WELL NO. Crooked Canyon Unit #4 API# 43-047-31033

APPLICATION FOR PERMIT TO DRILL, DEEPEN, OR PLUG BACK

SUBJECT: APD MINERAL EVALUATION REPORT

NEPA CATEGORICAL EXCLUSION REVIEW

CROOKED CANYON #4
SEC. 28, T14S, R23E, SLB&M.

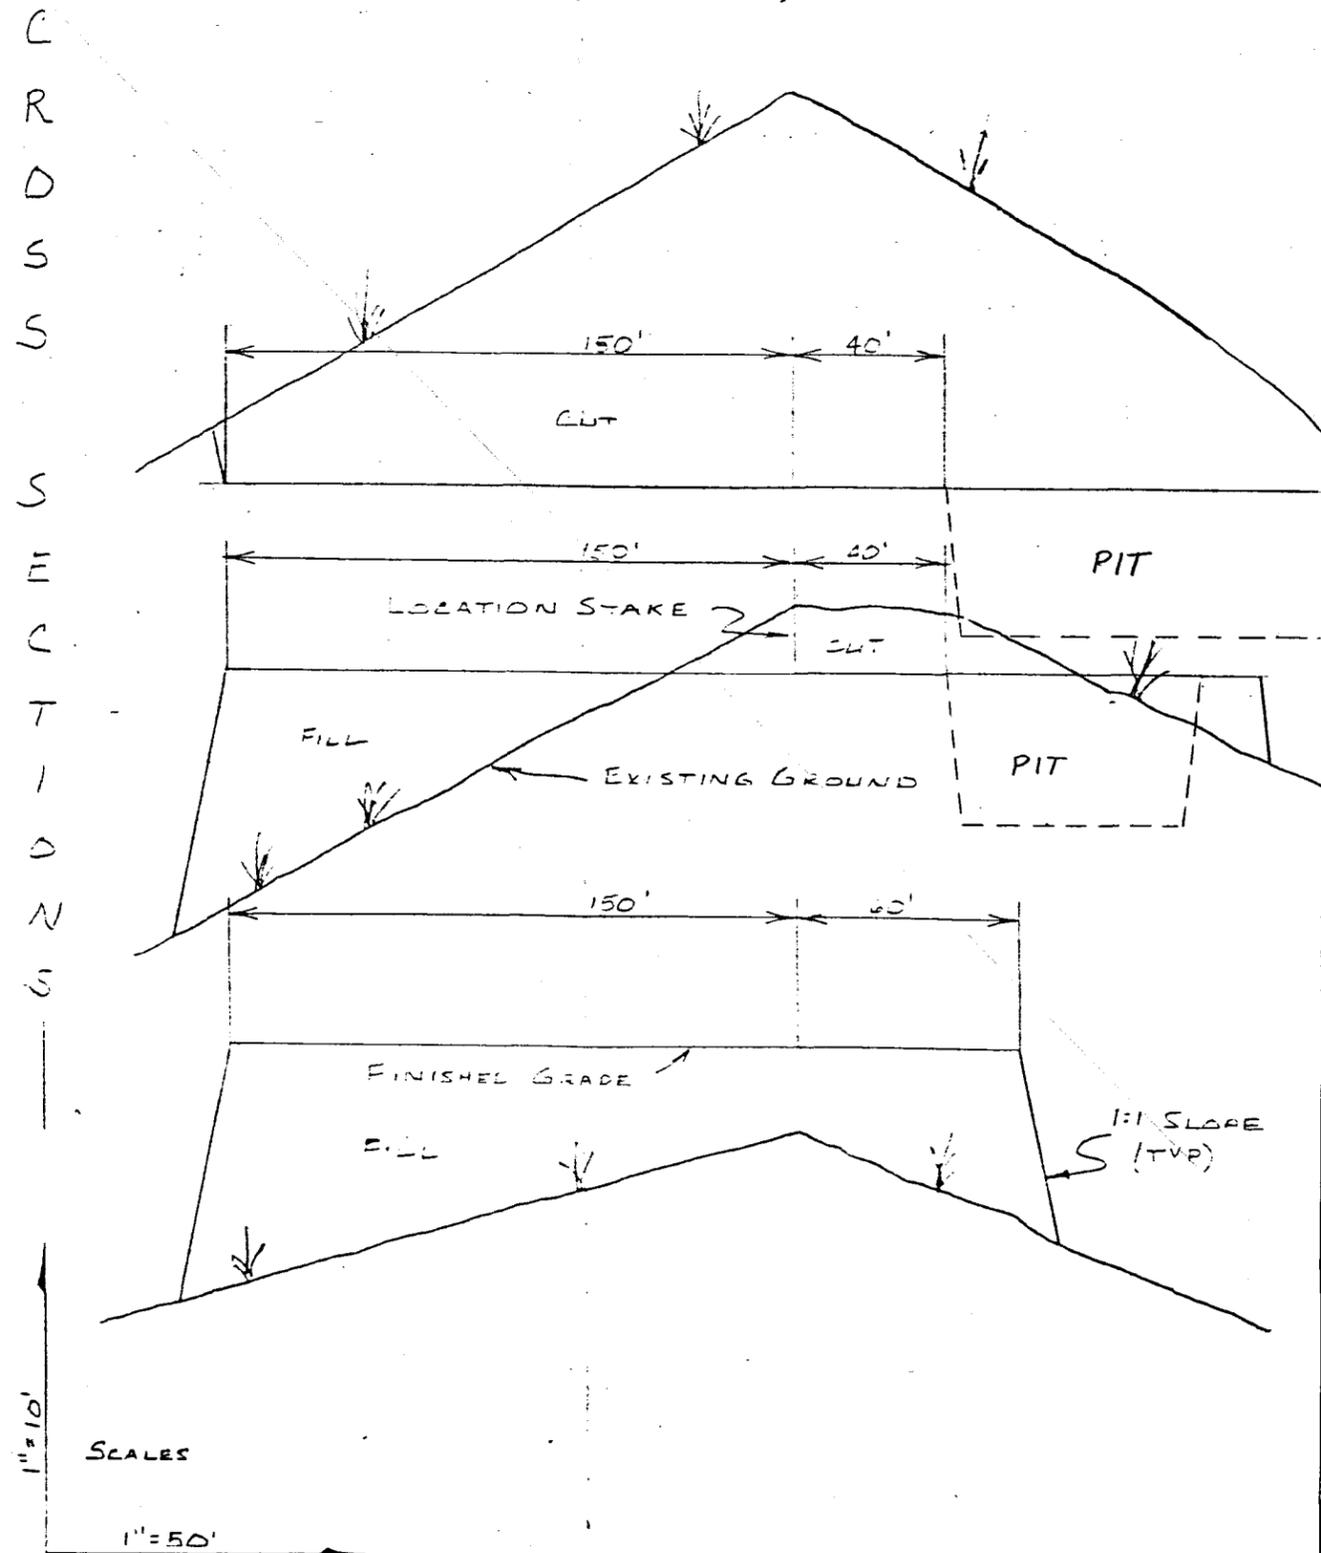
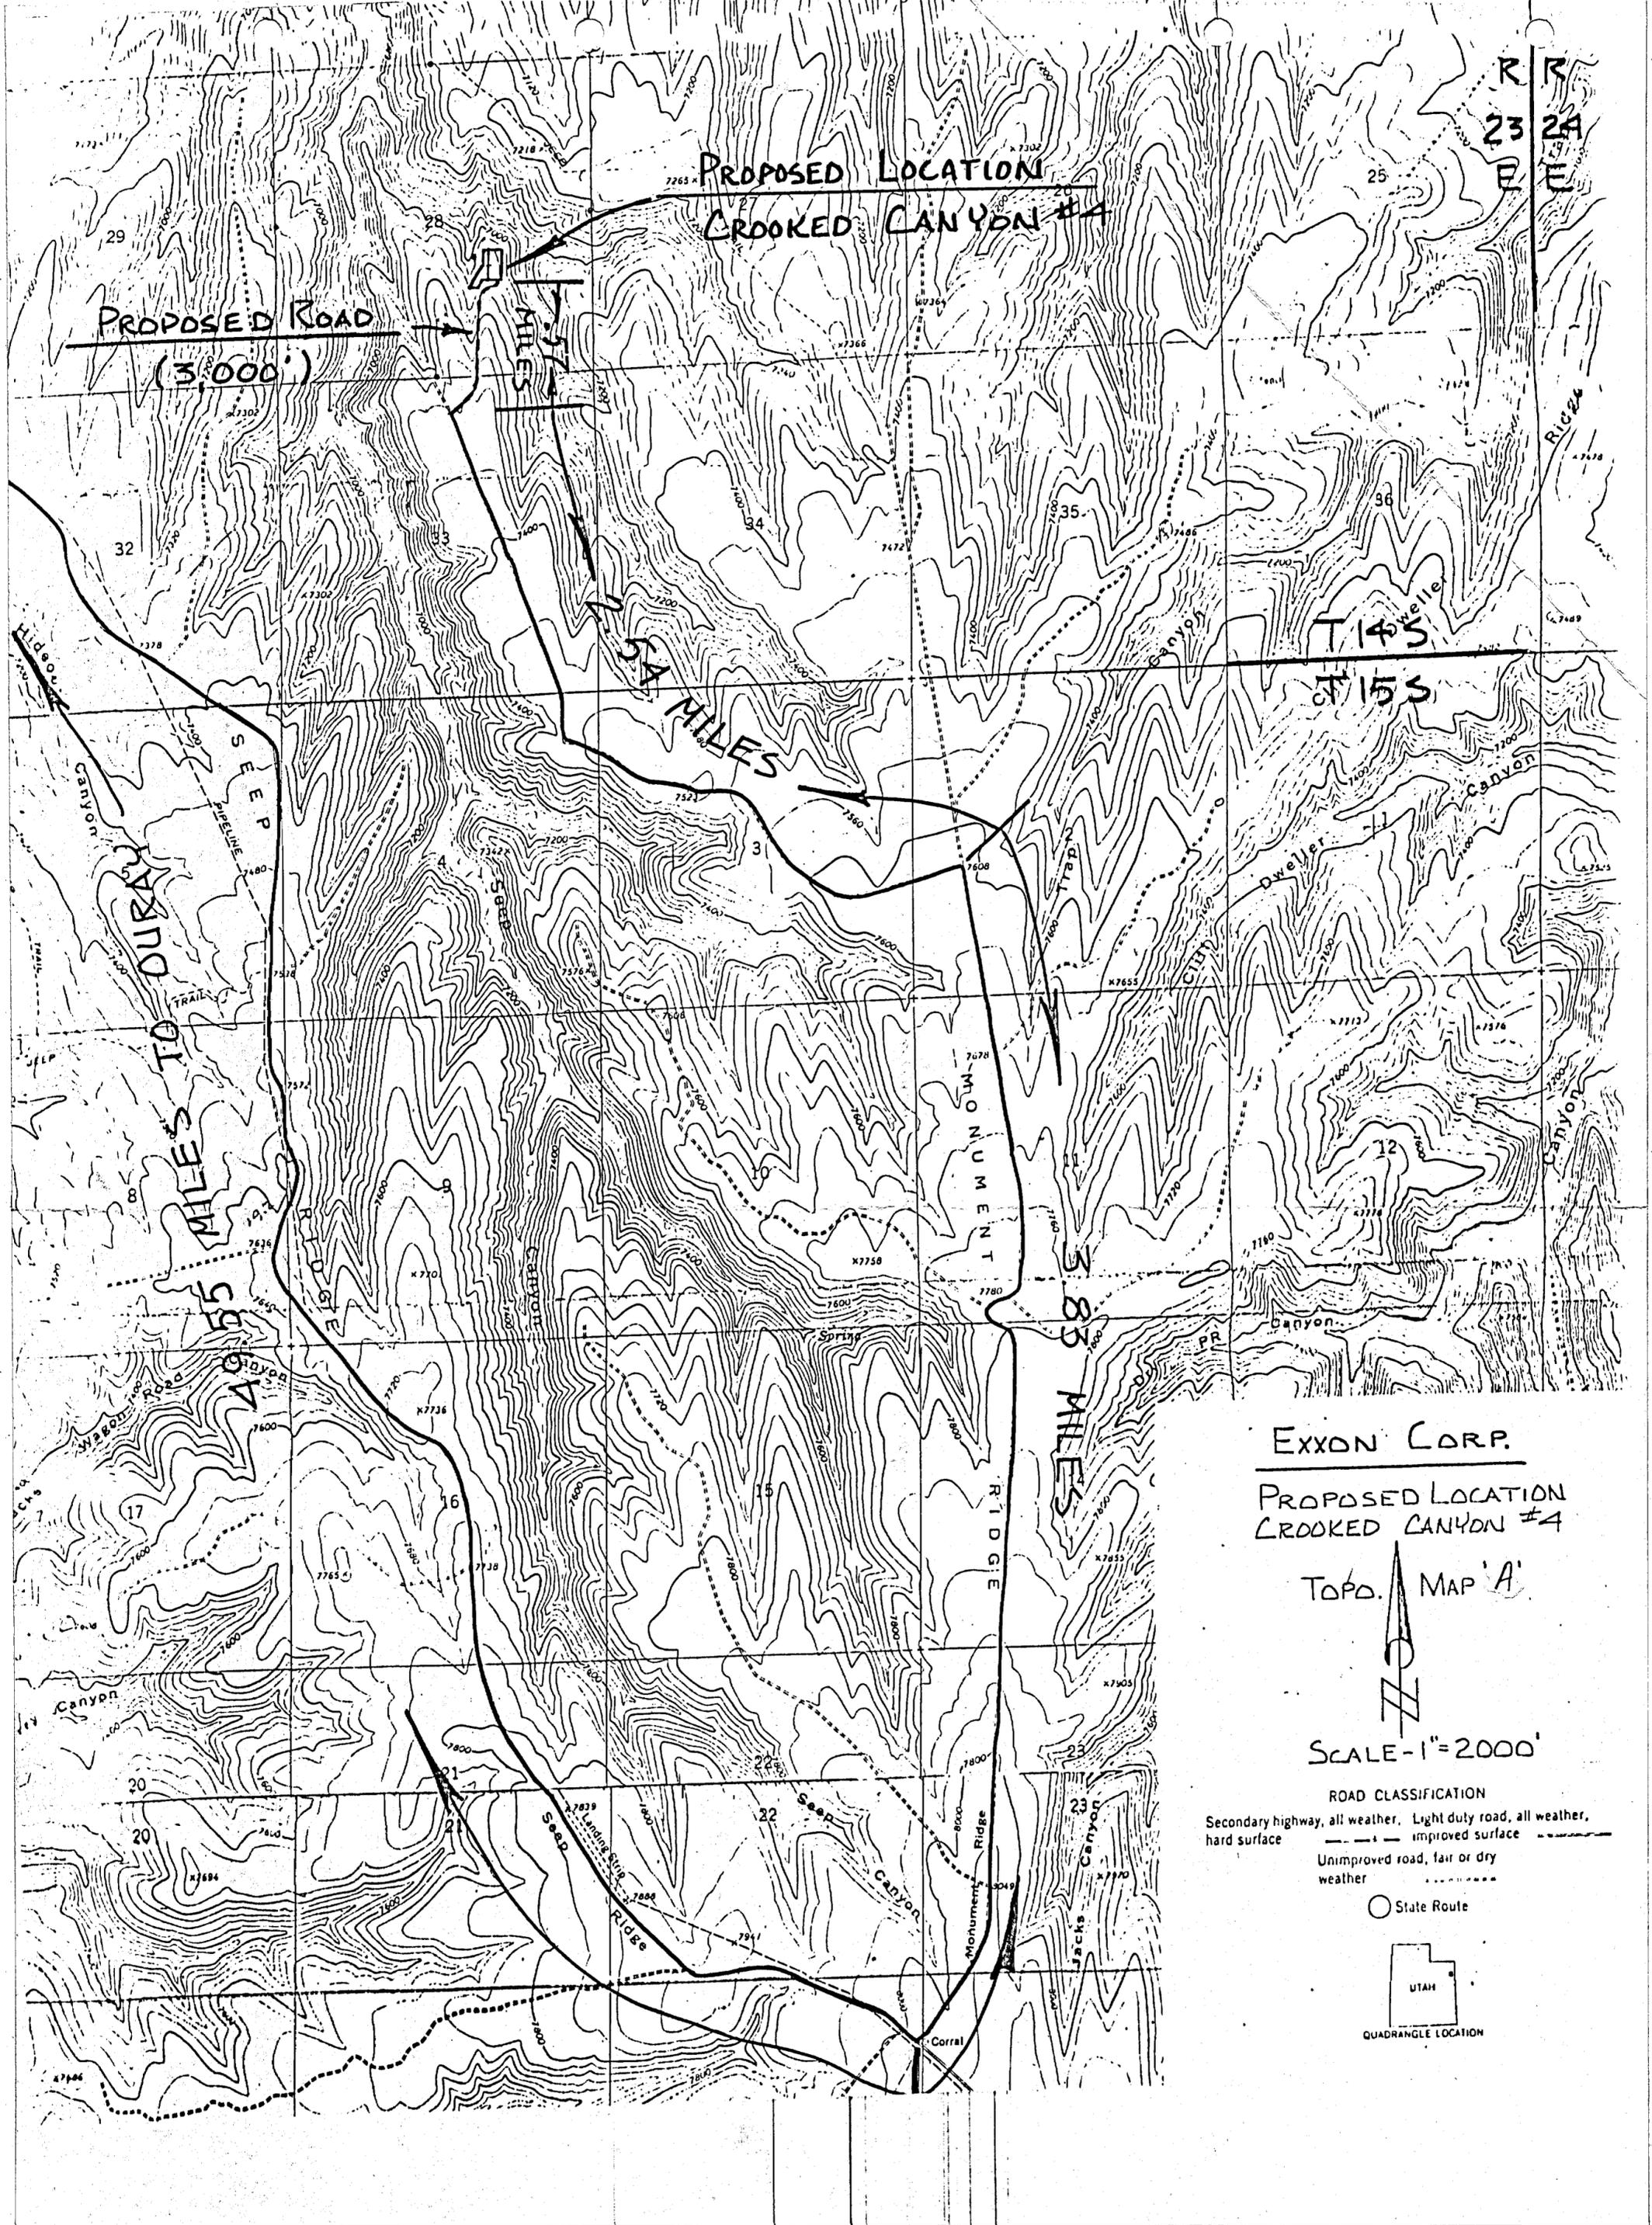
Modify Location or Access Road: Based on the topography the pits will probably require lining to prevent seepage through bedrock.

11. The reserve pits will be lined if necessary.
12. The top 4" of topsoil will be stockpiled between reference corners #7 and #8.
13. The brush and trees will be stockpiled between reference corners #6 and #7.
